# Technical Service Information

## **FORD AXOD-E CONVERTER TURBINE SPLINES CHANGE FROM 23 TEETH TO 25 TEETH**

Figure 2

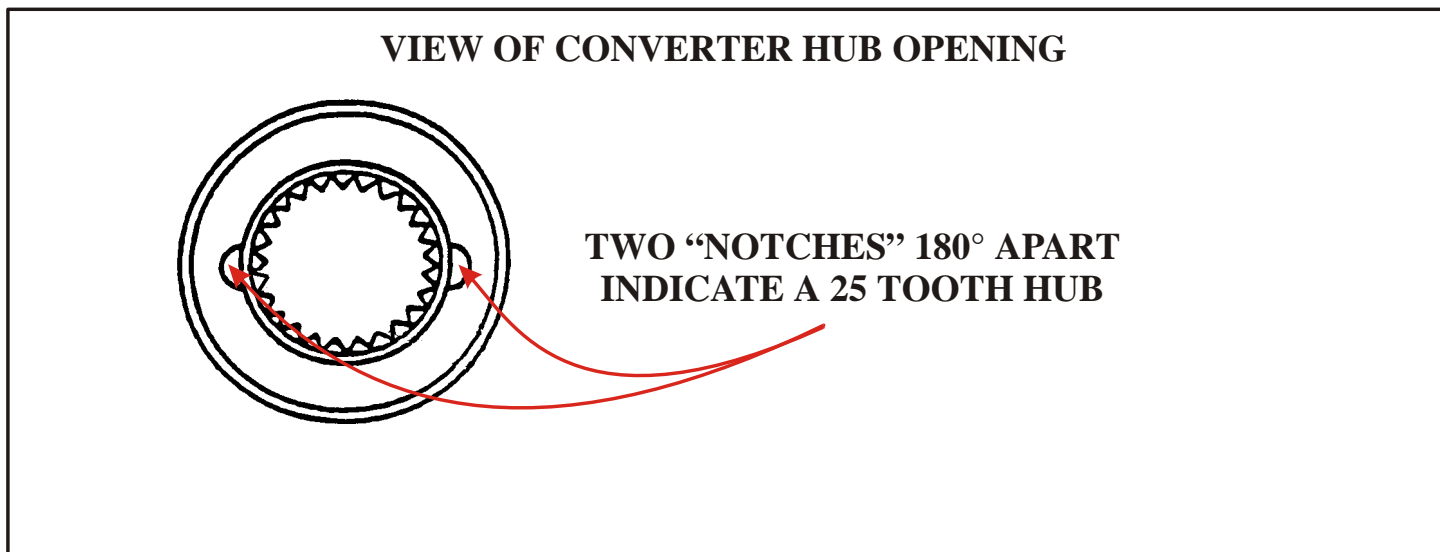
(1) **TORQUE CONVERTER** - Converter turbine hub splines changed from 23 teeth to 25 teeth. To identify this change the converter "Stamp Code" was changed. Refer to the Converter Stamp Code Chart in Figure 1. The 25 tooth converter can also be identified by looking down into the converter hub, as shown in Figure 2, and the converter hub will have two notches outside the spline area, and is very easy to see (See Figure 2).

If replacement of either the torque converter and/or turbine shaft is required, ensure that equal number of splines exist on the mating part.

***IT IS POSSIBLE TO INSTALL A 25 TOOTH CONVERTER ONTO A 23 TOOTH TURBINE SHAFT, IF THIS OCCURS, THE VEHICLE WILL HAVE NO FORWARD OR REVERSE MOVEMENT,***
